Subject: **FCC Class II Permission Change Request for FCC ID: ZT5-F2**

This is to request a Class II Permission Change Request for FCC ID: ZT5-F2, originally granted on 01/16/2025.

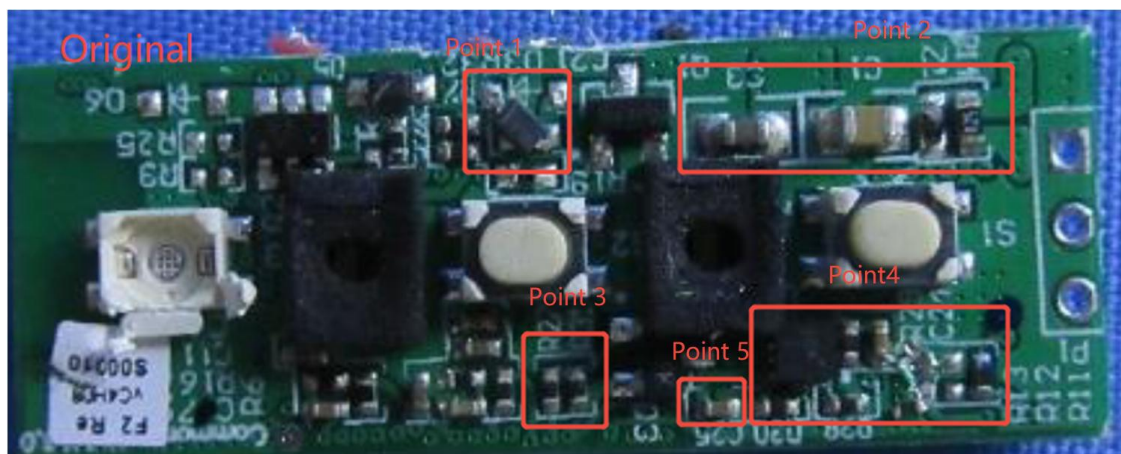
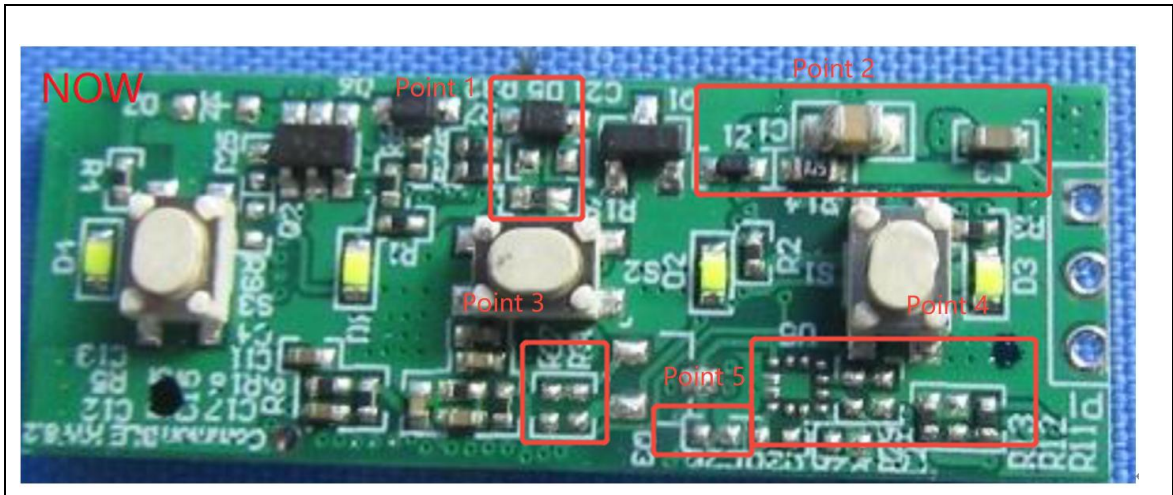
- 1. Add one new model F2S™ Double Sonic in this application which is the same as the original model in Electronic or Electrical characters.
- 2. The Battery capacity of F2S™ Double Sonic is 680mAh, and the Battery capacity of original model F2S™ and F2™ is 520mAh. And the new model and the original models also have Motor difference.

| Battery Capacity | F2S™ Double Sonic                                                                   | F2S™                                                                                 | F2™                                                                                   |
| Motor            | F2S™ Double Sonic                                                                   | F2S™                                                                                 | F2™                                                                                   |

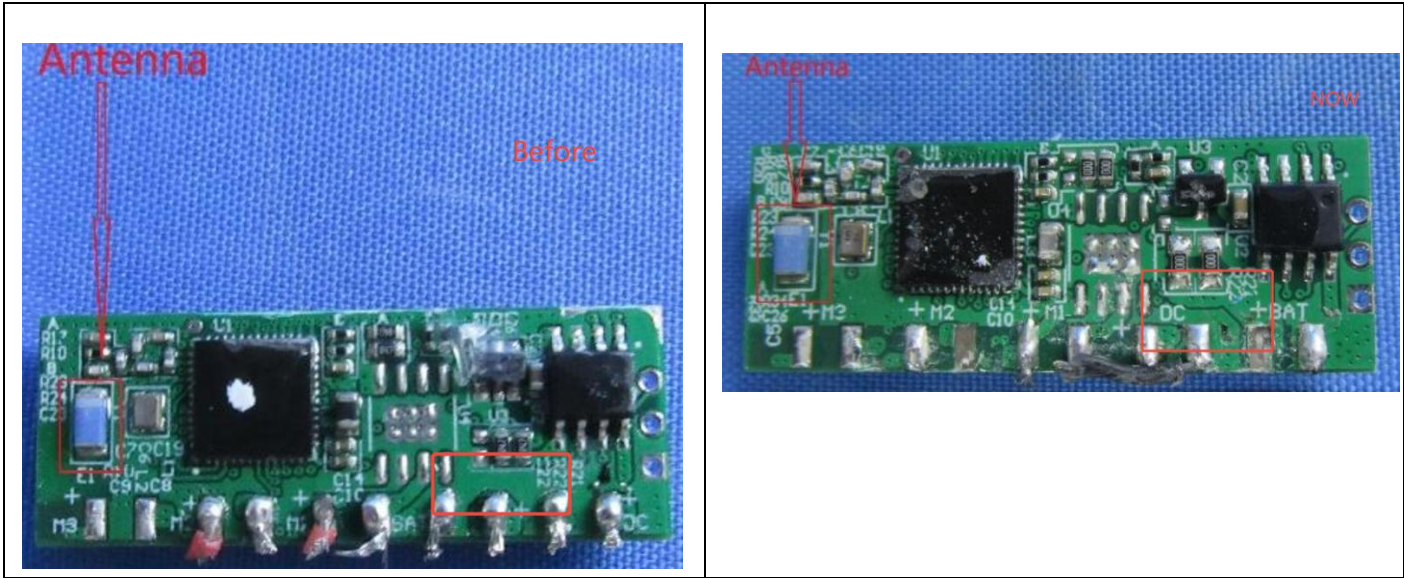
3. Updated standards from "RSS-247 Issue 3" to "RSS-247 Issue 4". The standard compliance requirements for this update have been verified.
4. Updated the FVIN from "F2\_REVD" to "REV.A" which has no impact on RF characteristics.
5. A few changes with PCB layout including changing or removing some components.

| Item   | Before      |                                                       | After   |                                                       | Comment                                  |
|--------|-------------|-------------------------------------------------------|---------|-------------------------------------------------------|------------------------------------------|
| Ponit2 | C3          | CAP 10uF 10V ±20% 0603 X5R                            | Z1      | TVS, 5V, 0402, ESD PROTECTION, 30KV                   | Change of Electronic Component Placement |
| Ponit3 | R27         | RES 20 OHM 1/16W 5% 0402                              | N/A     | N/A                                                   | Remove this resistor                     |
|        | R31         | RES 10K OHM 1/16W 5% 0402                             | N/A     | N/A                                                   | Remove this resistor                     |
| Point4 | C24         | CAP 0.1uF 16V 0402 X7R                                | N/A     | N/A                                                   | Remove this capacitor                    |
|        | R30,R28,R29 | RES 4.7K OHM 1/16W 5% 0402                            | N/A     | N/A                                                   | Remove these resistors                   |
|        | U5          | IC, SENSOR, 3-AXEX ACCELEROMETER, DA217               | N/A     | N/A                                                   | Remove this chip                         |
| Point5 | C25         | CAP 0.1uF 16V 0402 X7R                                | N/A     | N/A                                                   | Remove this capacitor                    |

6. Some traces on the PCB have been revised, detail as below:
